13 December 2021

PC210082 (PC82): Private Plan Change Request to the Operative Selwyn District Plan from Brookside Road Residential Limited in Rolleston (Brookside Road) – Request for further information

Figure 1 Extent of Selwyn District Council Designations (outlined and hatched in red)

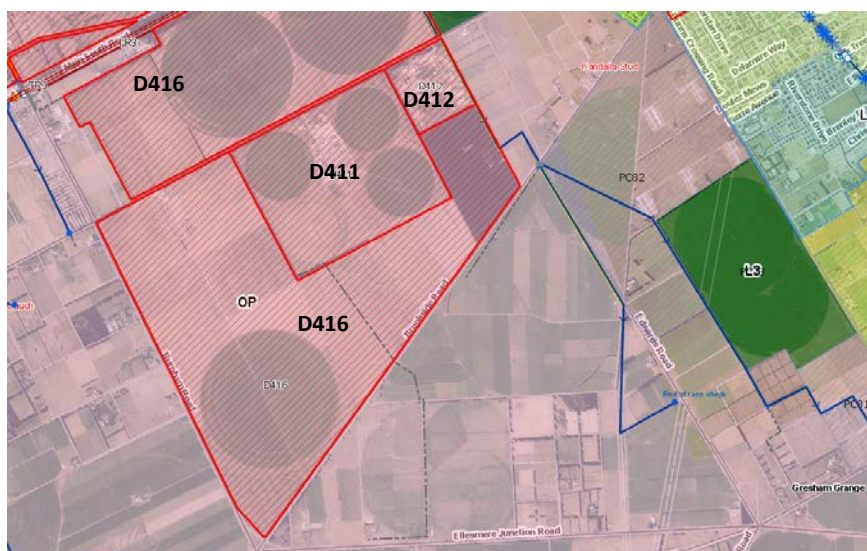
34. Figure c on page 5 does not accurately reflect the full extent of the designations associated with the Pines Wastewater Treatment Plant. Designation D416 extends south of the area shown down to Brookside Road, as per the figure below. Please acknowledge the full extent of the various designations associated with both the Pines Wastewater Treatment Plan and Resource Recovery Park and advise if the proximity of the designations, being some 180m from the edge of the plan change area has an impact on the site of the plan change request.
